## SUNDRY NOTICES AND REPORTS ON WELLS

Cimarex respectfully requests approval for a multibowl well head, please see attached diagram and procedure.

## DRILLING CONDITIONS OF APPROVAL

OPERATOR'S NAME:	Cimarex Energy Company
LEASE NO.:	NMLC061873B
WELL NAME & NO.:	4H-Cotton Draw 9L Federal
SURFACE HOLE FOOTAGE:	459'/S & 776'/W
BOTTOM HOLE FOOTAGE:	330'/N & 804'/W
LOCATION:	Section 9, T.25 S., R.32 E., NMPM
COUNTY:	Lea County, New Mexico

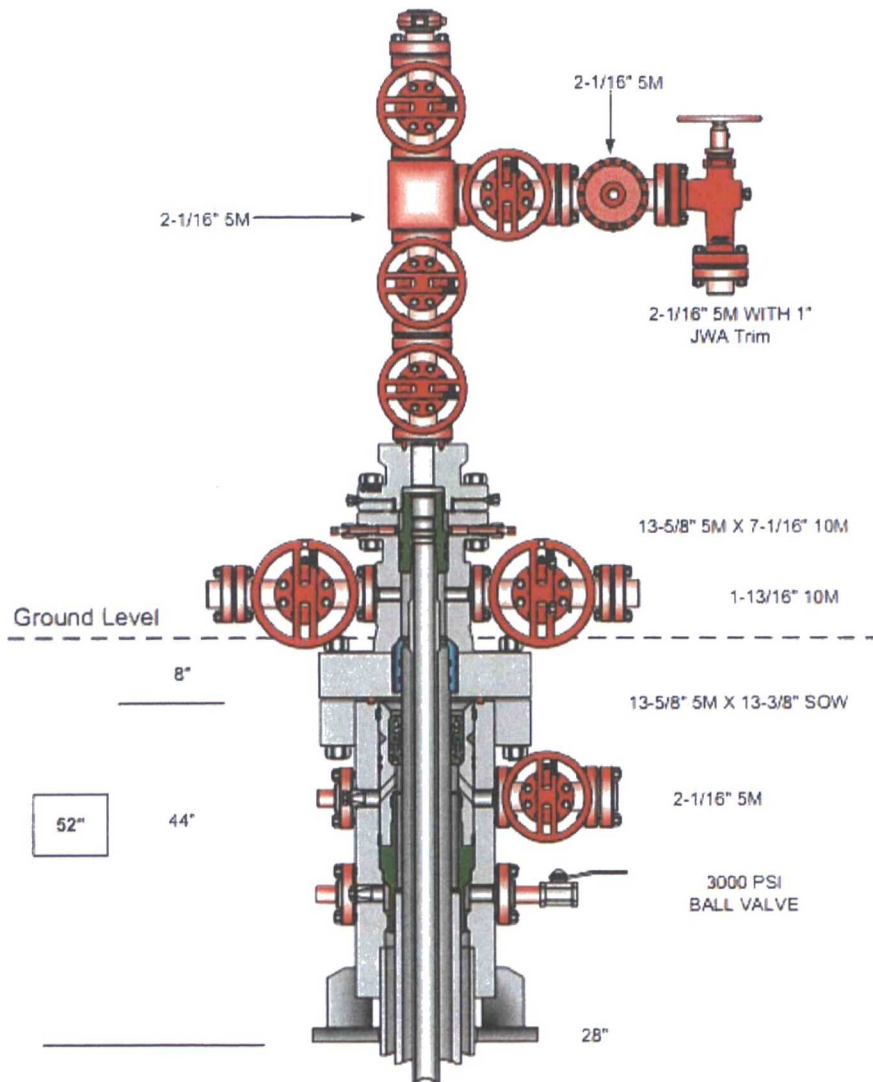
**Operator has proposed a multi-bowl wellhead assembly. This assembly will only be tested when installed on the surface casing. Minimum working pressure of the blowout preventer (BOP) and related equipment (BOPE) required for drilling below the surface casing shoe shall be 3000 (3M) psi.**

- a. Wellhead shall be installed by manufacturer's representatives, submit documentation with subsequent sundry.**
- b. If the welding is performed by a third party, the manufacturer's representative shall monitor the temperature to verify that it does not exceed the maximum temperature of the seal.**
- c. Manufacturer representative shall install the test plug for the initial BOP test.**

**If the cement does not circulate and one inch operations would have been possible with a standard wellhead, the well head shall be cut off, cementing operations performed and another wellhead installed.**
